# LCB INTERNATIONAL (BD) LTD.

Plot 48, Sector 7, CEPZ, Chattogram  
(22.299803, 91.776259)

11 February 2025

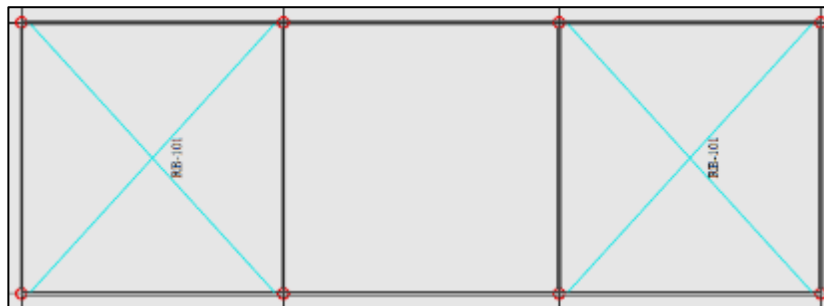
**Description:** Storage live load has been considered as 105 psf on the 6th floor in load plan. But as per BNBC minimum live load criterion, storage live load must be considered 125 psf. The factory is required to consider 125 psf for storage live load and update DEA accordingly.

**Observation-3:** Discrepancies in as-built drawings (Production Building).

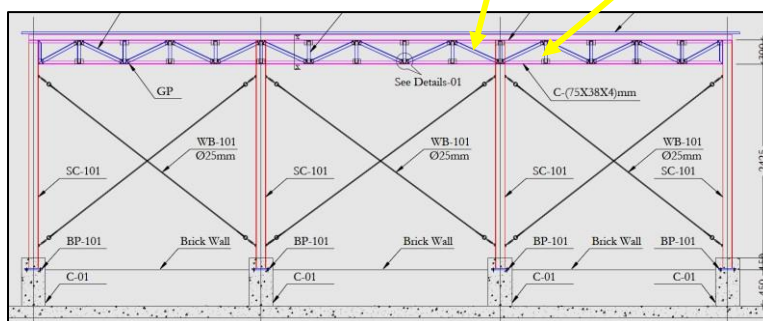
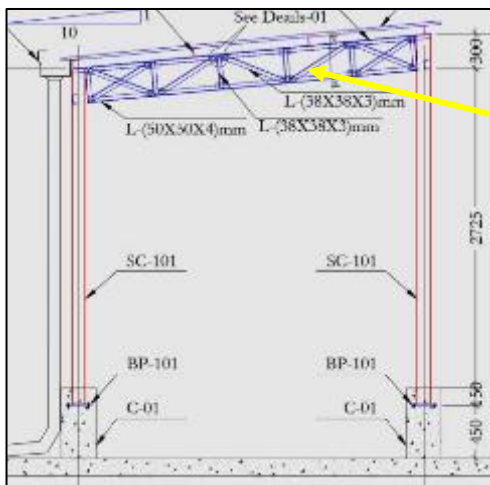
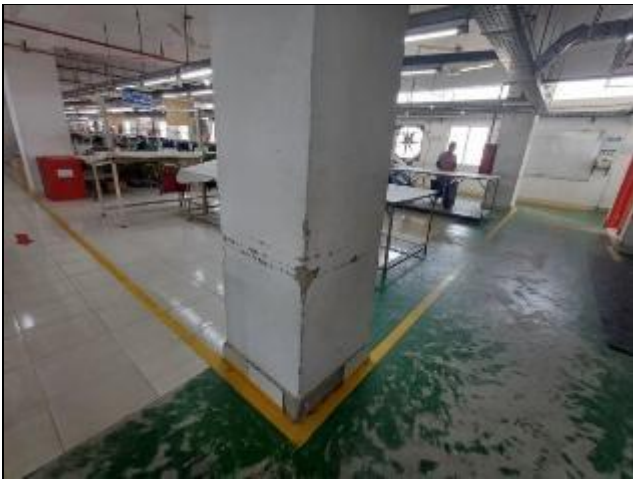
200 mm build-up at 3rd-floor toilet

100 mm false slab at typical floor toilet area

Roof bracing layout (RO plant)

**Description:** During the inspection, undocumented 200 mm build-up at the 3rd-floor toilet and 100 mm false slab at typical floor toilets were observed. Roof bracing was missing, and truss mismatches were observed at the RO plant shed.

The building engineer is required to survey the whole structure and update as-built drawings as per site conditions.
